Mountain View Residences Phase II

Community Development Department

December 19, 2017

Town Council Concerns, First Reading, December 5, 2018

Offset for Energy Usage for Heated Sidewalk

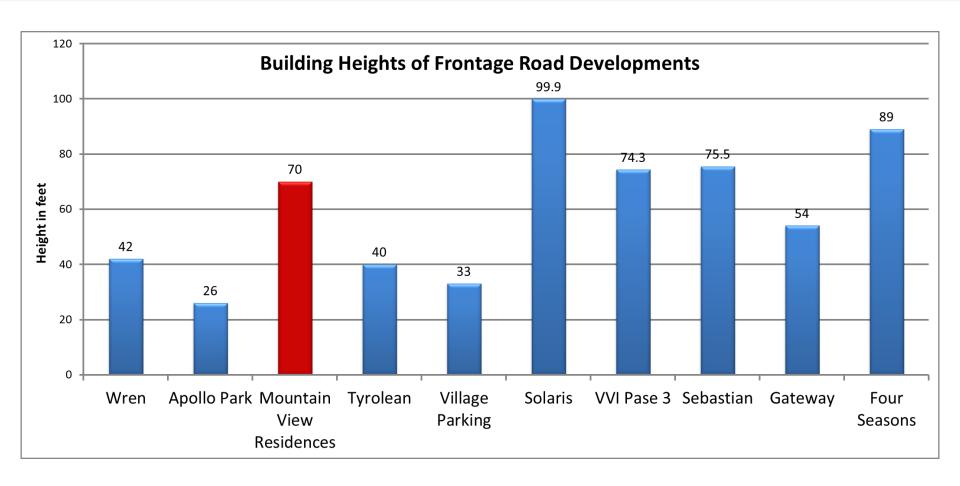
In light of environmental concerns, members of council recommended that the proposed energy required for the heated sidewalk be offset by renewable energy.

The proposed heated sidewalk would require a 20 kW solar system in order for a 100% offset. Per the solar consultant and project architect, the maximum system that can be supported on the Phase II structure is 10 kW, resulting in a 50% offset.
